Addendum No. 3

RFT 25-055 - Washroom Renovation - Central Public School

CENTRAL PUBLIC SCHOOL WASHROOM AND STORAGE ROOM RENOVATIONS

ADDENDUM No. 3

KEY PLAN, SYMBOLS, SCHEDULES & DETAILS - MECHANICAL

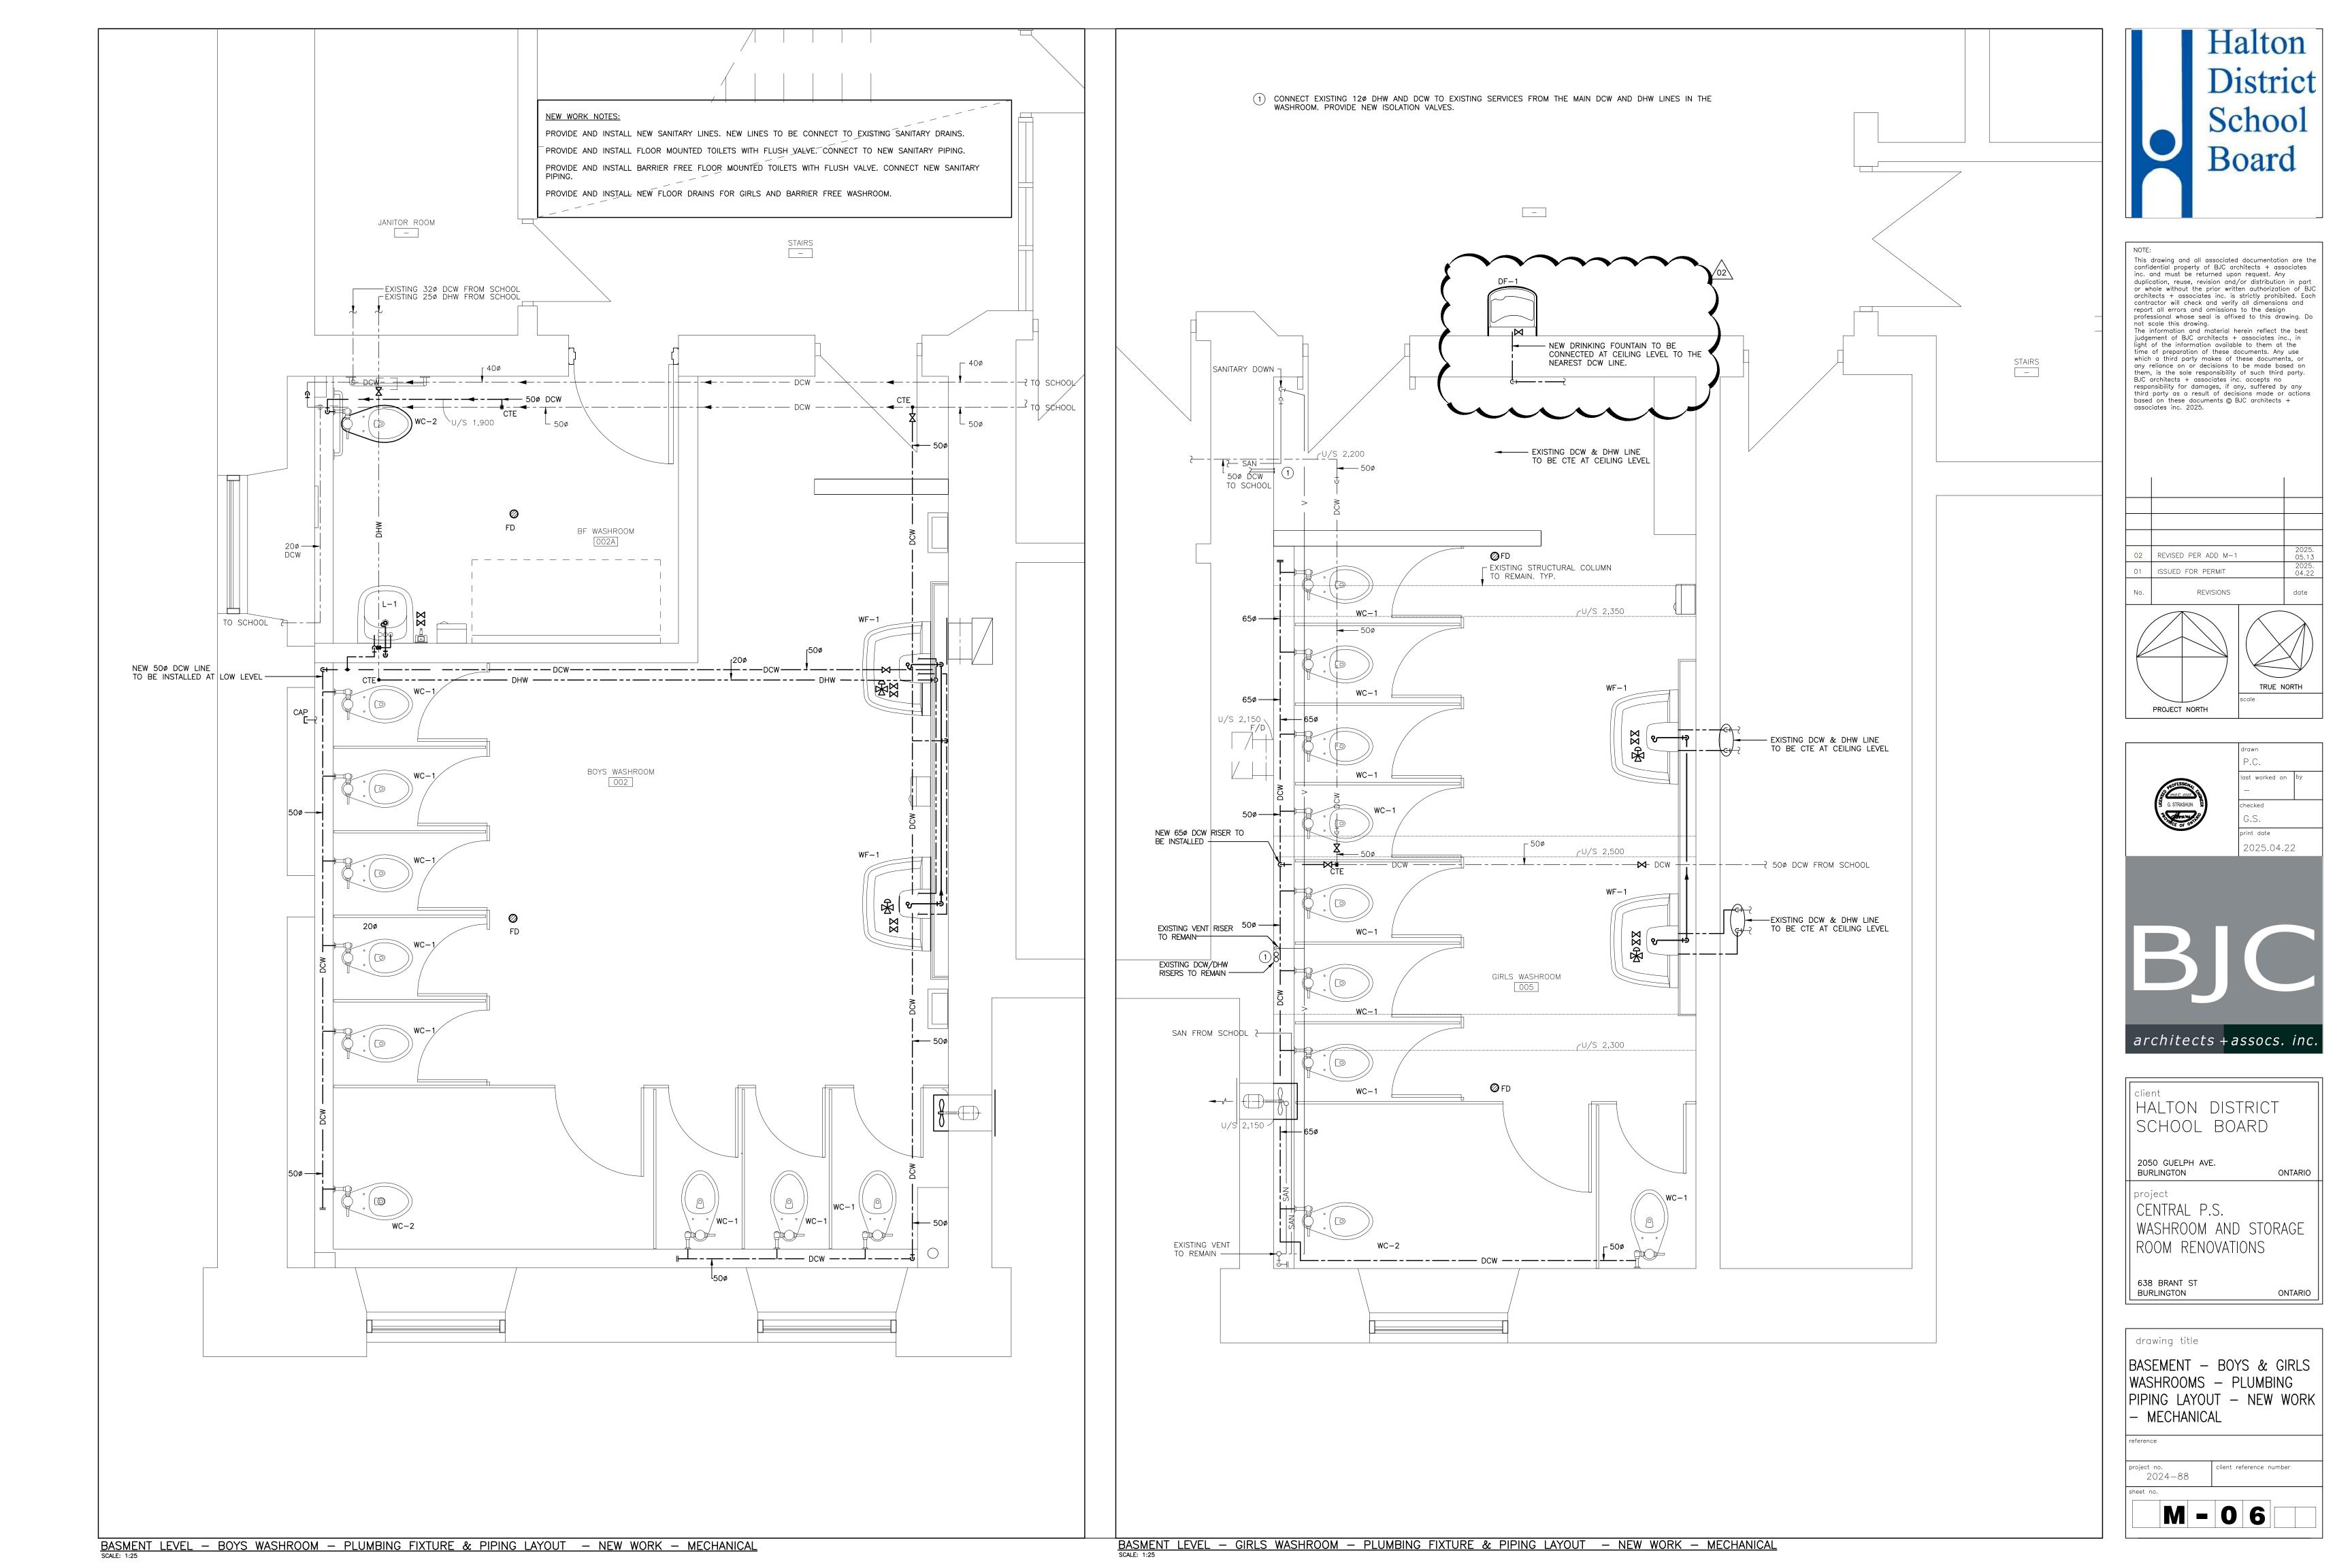
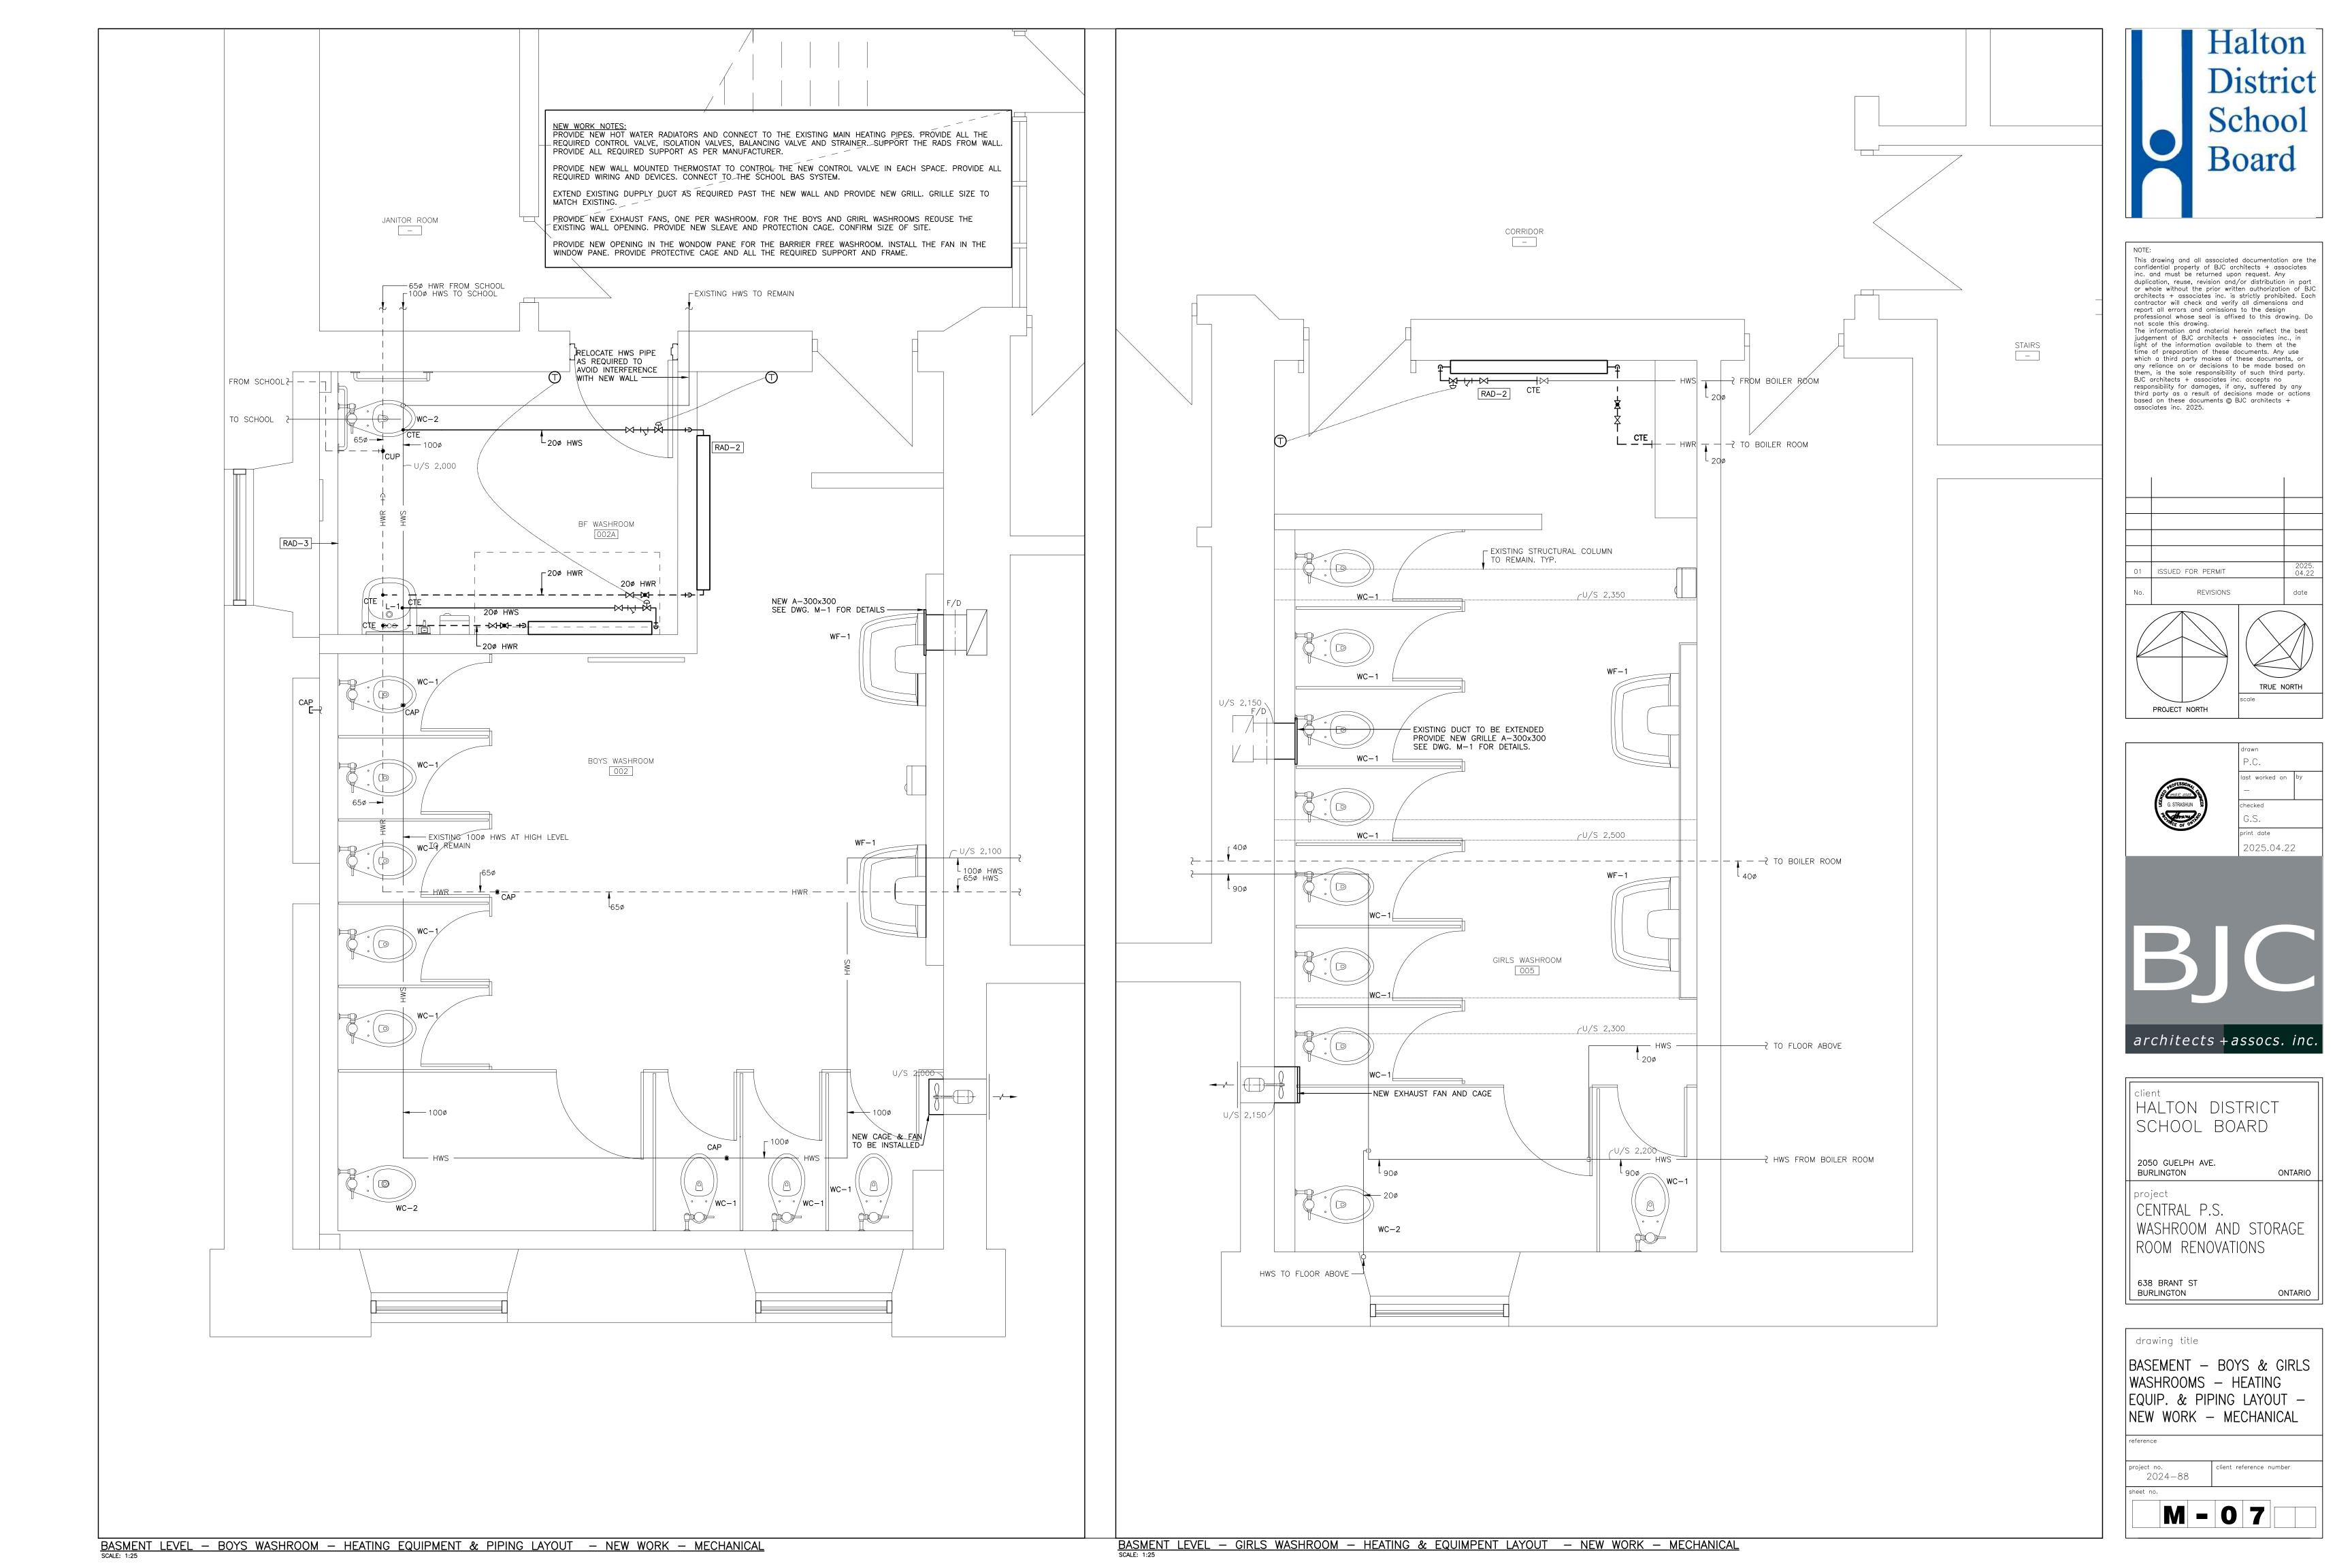
1.1 Refer to updated Mechanical drawings M-01 to M-07 attached to replace previously issued drawings M-01 to M-07.

3.1 Remove the existing drinking fountain and associated drain, vent and CW pipes located outside of Bous Washroom. Install new wash fountain as noted on the drawings. Connect to new drain, CW and vent pipes. Provide power supply for the new fountain as required by the manufacturer from the nearest available panel. The fountain to be water bottle filling station manufactured by Elkay model LZSG8WSLK, ADA approved, filtered water, refrigerated.

- 4.1 All the new HW heaters to be installed at high level.
- 4.2 Contractor to ensure that when removing any pneumatic controls, the tubes are maintained, cleaned and the existing system remains operational
